Dockets Nos. 50-247
and 50-286

RE: INDIAN POINT UNITS NOS. 2 AND 3

Enclosure:
Burnup-Dependent Correction
for Fission Gas Release
Models

FIGURE 1

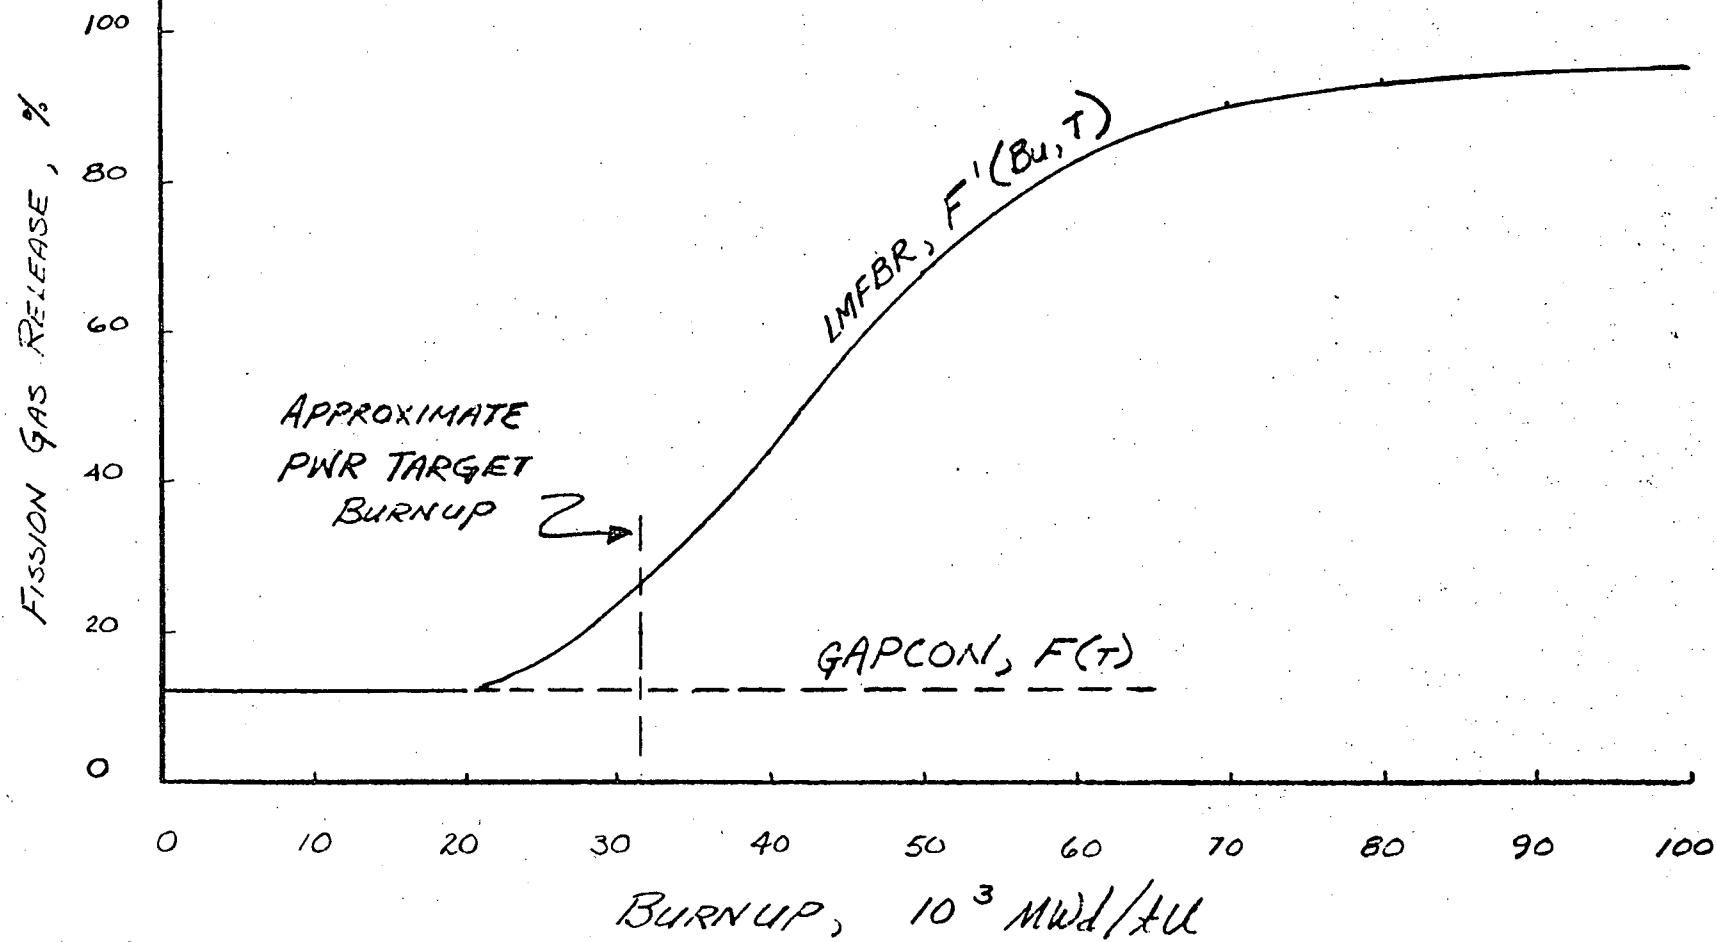
The following correction has been derived to give an increased release fraction $F^*(\text{Bu}, T)$ as a function of burnup and the uncorrected release prediction $F(T)$. Burnup Bu is the local burnup in megawatt-days per metric ton of uranium (MWd/tU), and T, which is not an explicit variable in the correction, is temperature.

$$F^*(\text{Bu}, T) = F(T) + [1 - F(T)] \frac{(1 - \exp[-0.436 \times 10^{-4}(\text{Bu} - 20000)])}{(1 + [0.665/F(T)] \exp[-1.107 \times 10^{-4}(\text{Bu} - 20000)])} \quad (1)$$

Figure 1 shows schematically how this correction would be applied to the GAPCON gas release model, which is independent of burnup. In the event an existing model contains a burnup dependence, $F(T)$ would be the predicted release fraction under the temperature conditions of interest, but with the burnup variable set equal to 20,000 MWd/tU.
